THE PRINTWORKS

819-829, HIGH ROAD, TOTTENHAM, LONDON, N17 8ER

PROPOSED GA L02 FLOOR PLANS (819 and 821)

PRINT-F3A-ZZ-02-GA-A-82123

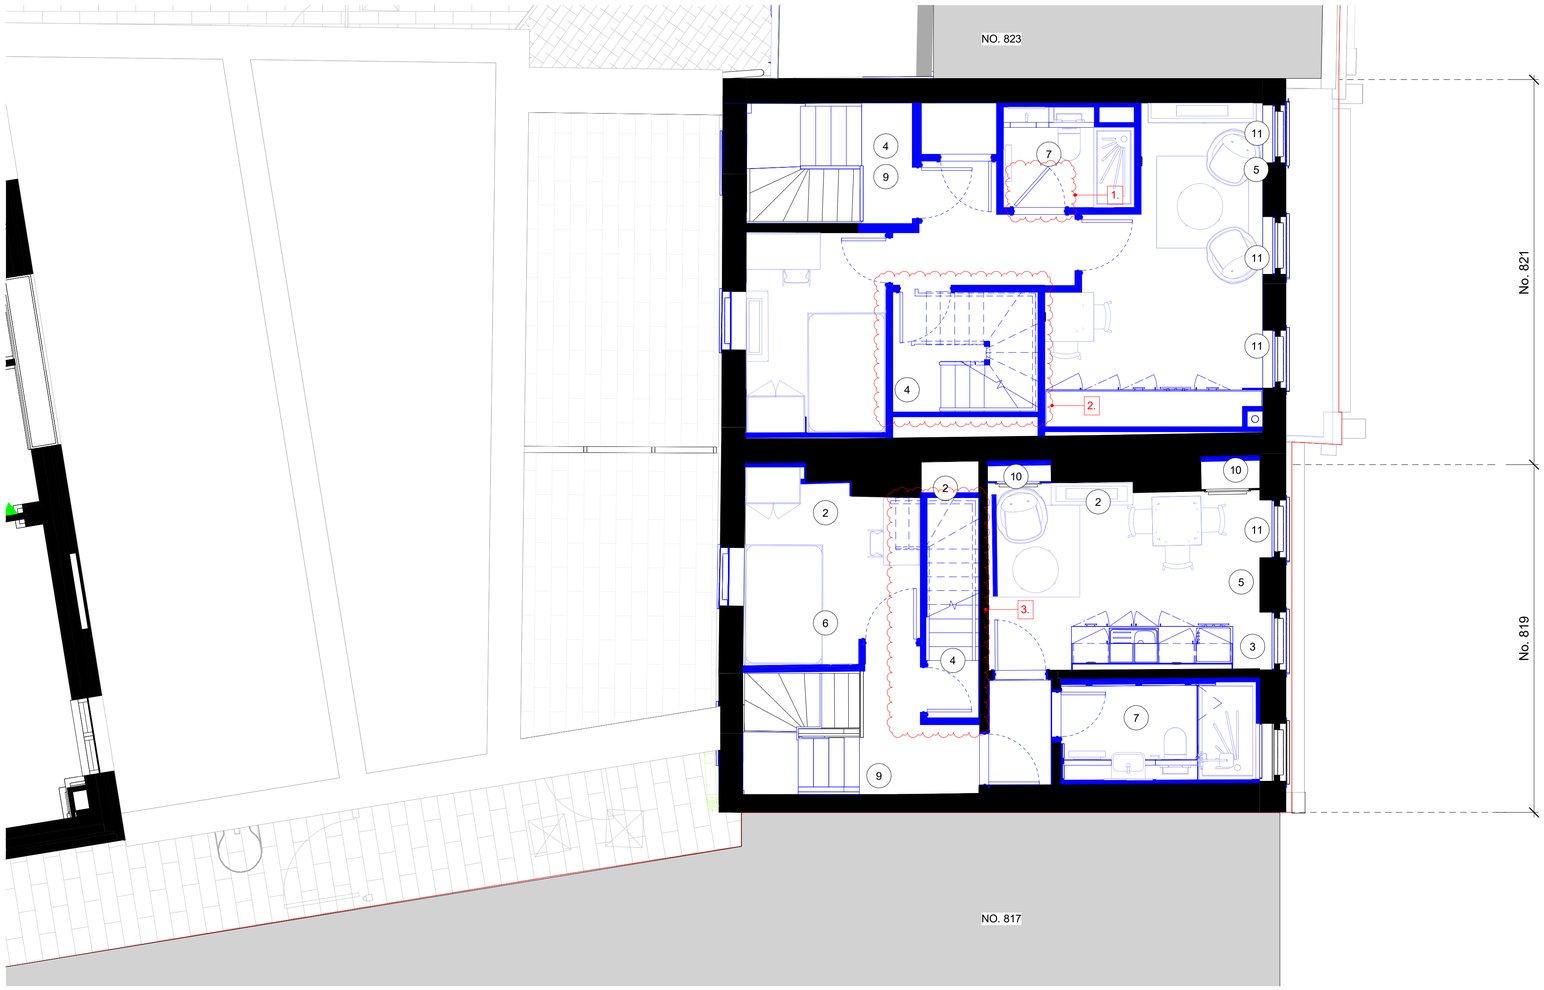
NMA 2 Updates:

1. Door to WC altered due to design development
2. Stair to No. 821 altered following site survey
3. Stair to No. 819 altered following opening up on site
